Docket Number: NEPR-MI-2022-0005

In Re: PLAN PRIORITARIO PARA LA ESTABILIZACIÓN DE LA RED ELÉCTRICA

Re: Requirement of Information

(a). Provide the underlying data in Excel file format with formulas intact and including any unit-specific detail for the two Figure 4 graphs of "Capacity (MW) On June 30, 2023" and "Actual Capacity (MW) 2024".

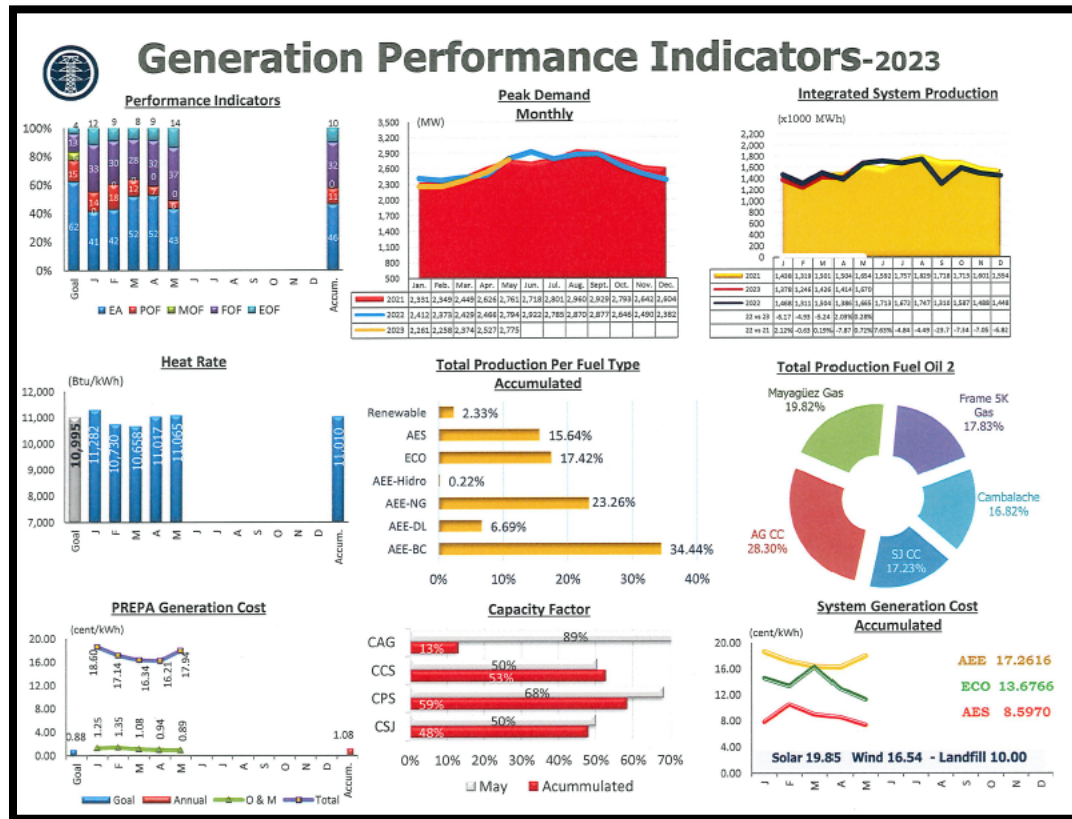
13. Document Attachment 1, Electric System Stabilization Plan, Version July 8, 2024. Section VIII. Generation System Status, subsection B. Post-Genera Generation System Metrics and Performance, including Figures 4 and 5 (pages 32-33).

Please refer to attachments GPR-PREB-NEPRMI20220005-20241205-#13(a).
